SUNDRY NOTICES AND REPORTS ON WELLS
Do not use this form for proposals to drill or to re-enter an
abandoned well. Use Form 3160-3 (APD) for such proposals.

Chaco 2306-18M #240H

WELL LOCATION AND ACREAGE DEDICATION PLAT

Operations Plan

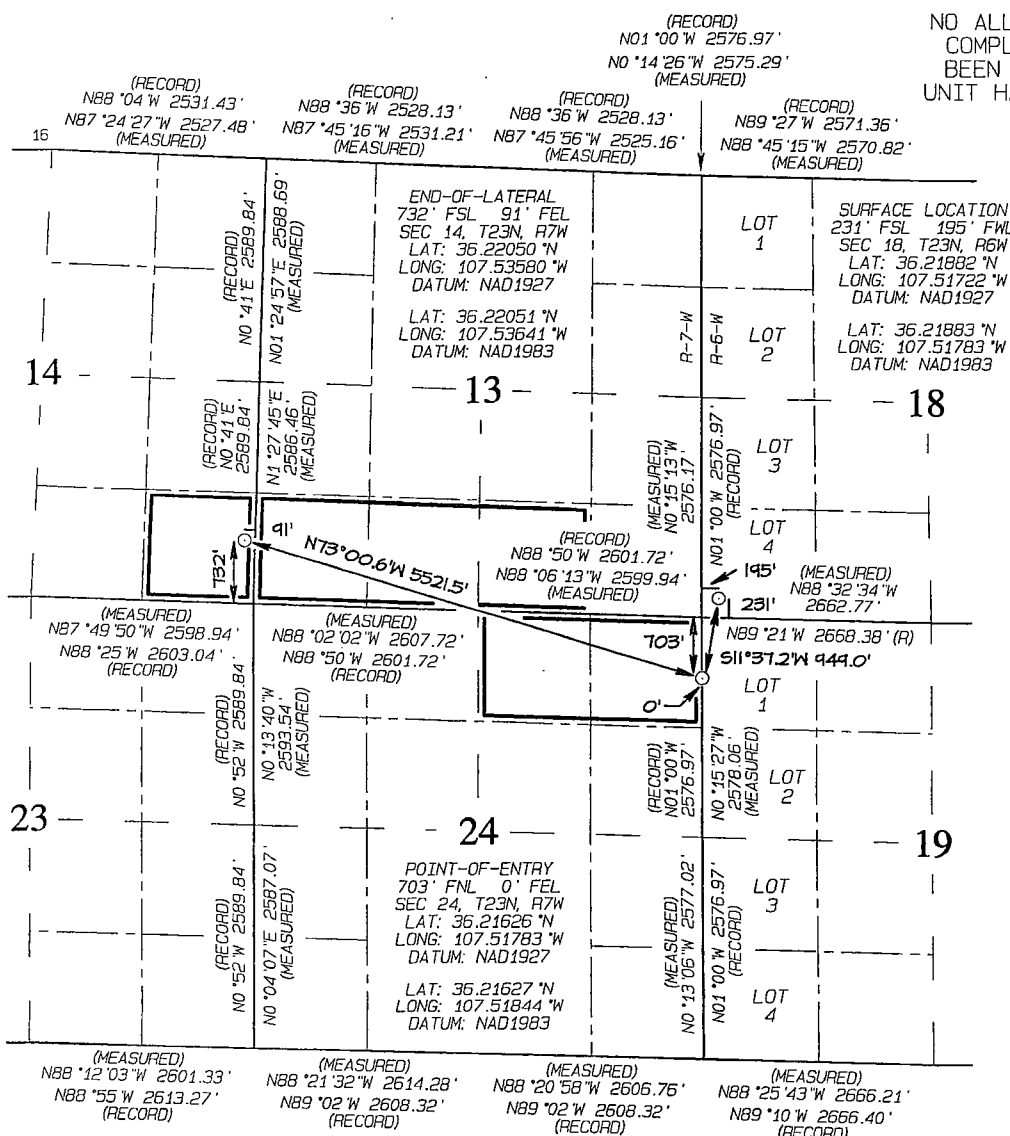
WPX plans to plans to realign the lateral on this well as per attached C-102, operations plan and directional plan. No new surface disturbance is required. Although this horizontal well will be drilled past the applicable setbacks, an unorthodox location application is not required because the completed interval in this well, as defined by 19.15.16.7 B(1) NMAC, will be entirely within the applicable setbacks. This approach complies with all applicable rules, including 19.15.16.14 A(3) NMAC, 19.15.16.14 B(2) NMAC, 19.15.16.15 B(2) NMAC, and 19.15.16.15. B(4) NMAC.

Project area may change depending on placement of perforations

Chaco 2306-18M #240H R5 mdv 10Jun14 Proposal Geodetic Report

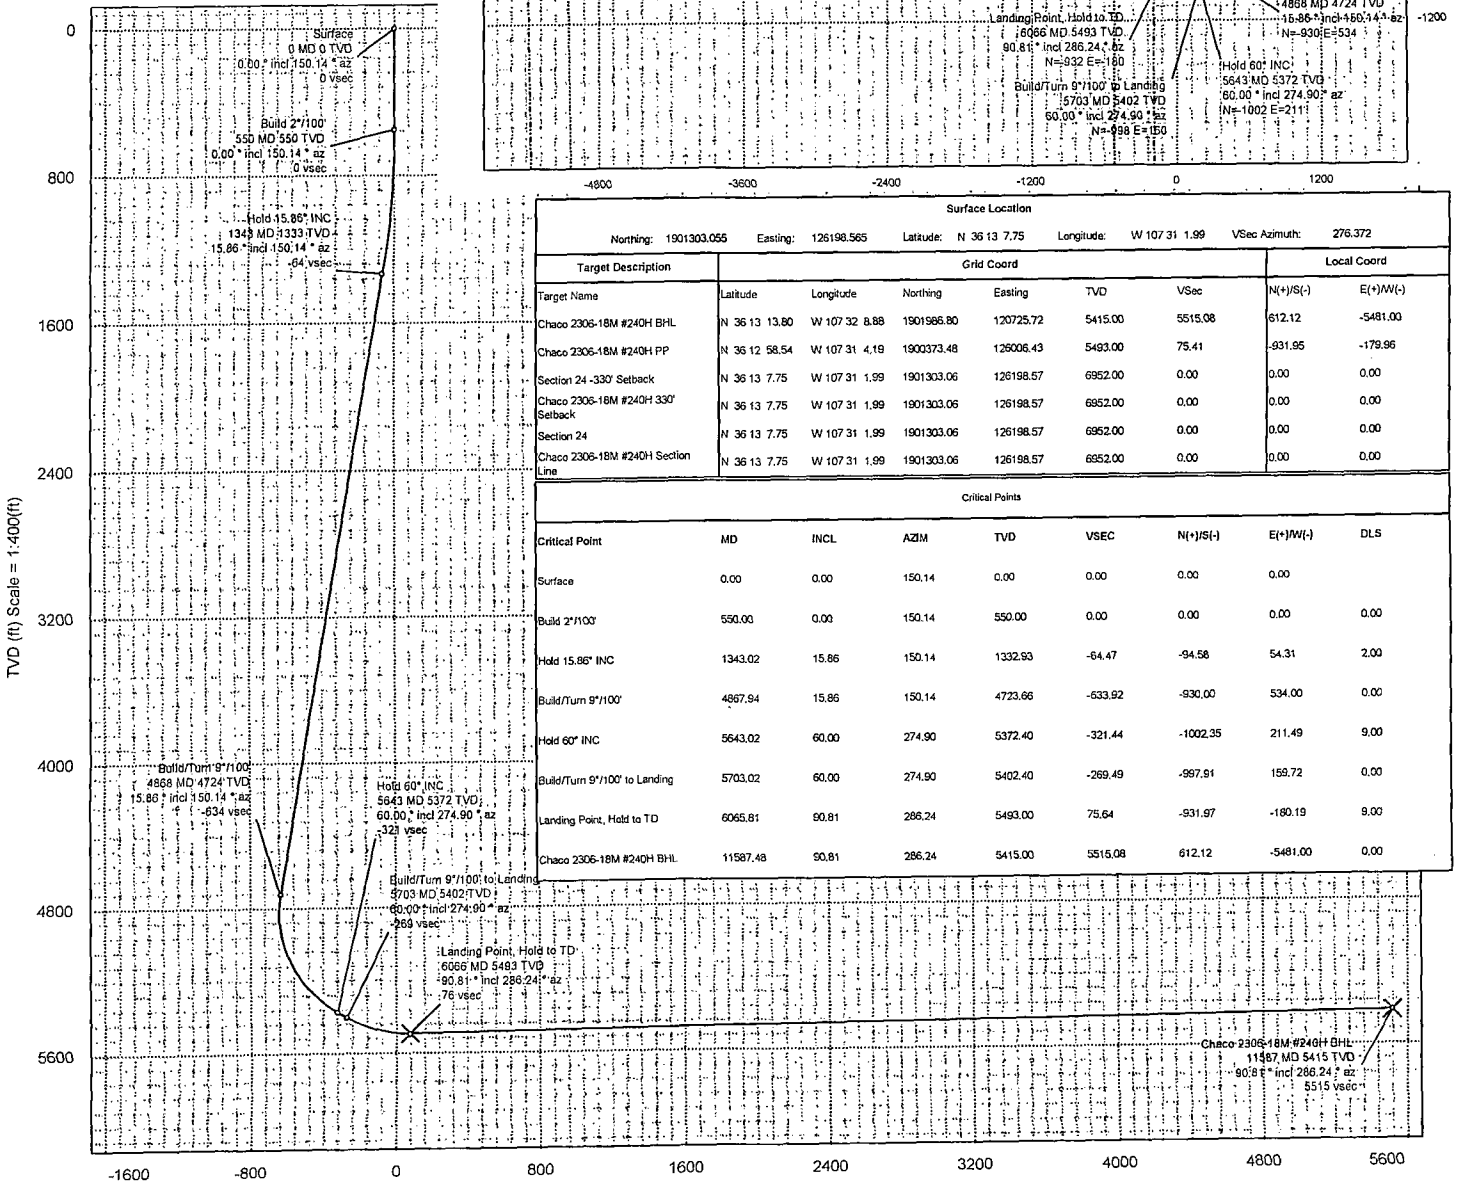
Note: Changes to formation tops, casing landing points, well TD and Directional Plan.
